Date Submitted	11/28/2018	Section	402.4.1.2	Proponent	Bereket Nigusse
Chapter	4	Affects HVHZ	No	Attachments	Yes
TAC Recommendation	Approved as Submitted				
Commission Action	Pending Review

Increases the Skylights area percentage allowed with daylight response control from 5% to 6%.

Code Change No: **CE97-16**

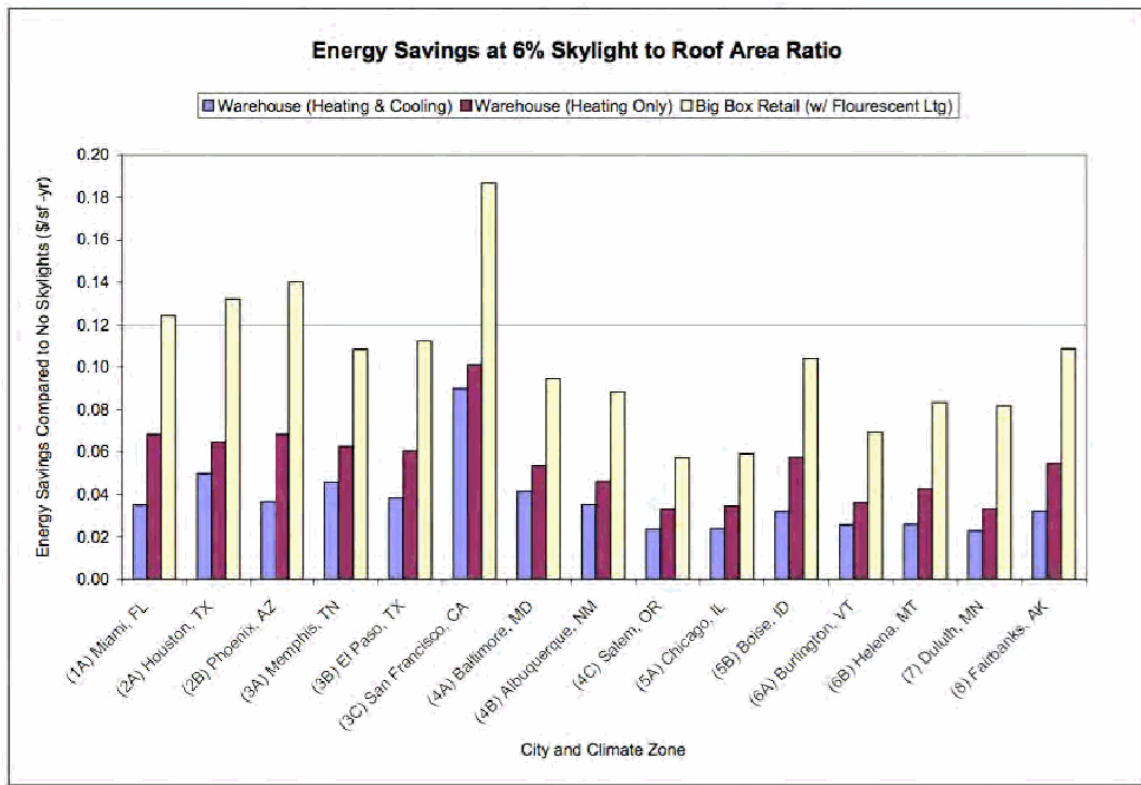
C402.4.1.2 Increased skylight area with daylight responsive controls. The skylight area shall be permitted to be not more than 5-6 percent of the roof area provided that daylight responsive controls complying with Section C405.2.3.1 are installed in daylight zones under skylights.

Reason: This proposal changes the maximum skylight area when daylighting controls are used from 5% to 6% of the roof area. When the toplighting requirements were first added to ASHRAE 90.1-2010 and the 2012 IECC, the research studies they were based on showed positive energy savings for skylight areas > 6% in all climate zones (for example, see figure below). ASHRAE 90.1 has the same cap on skylight area as the IECC of 3% when no daylight controls are provided, but allows 6% with proper toplighting instead of 5%. This proposal updates the percentage allowed with daylight controls to the same 6%. This will also help reduce potential conflicts where the minimum toplighting requirement of C402.3.2 would require more skylight area than allowed by this section.

The skylight area shall be permitted to be not more than 56 percent of the roof area provided that daylight responsive controls complying with Section C405.2.3.1 are installed in ~~daylight toplit zones~~ under skylights.
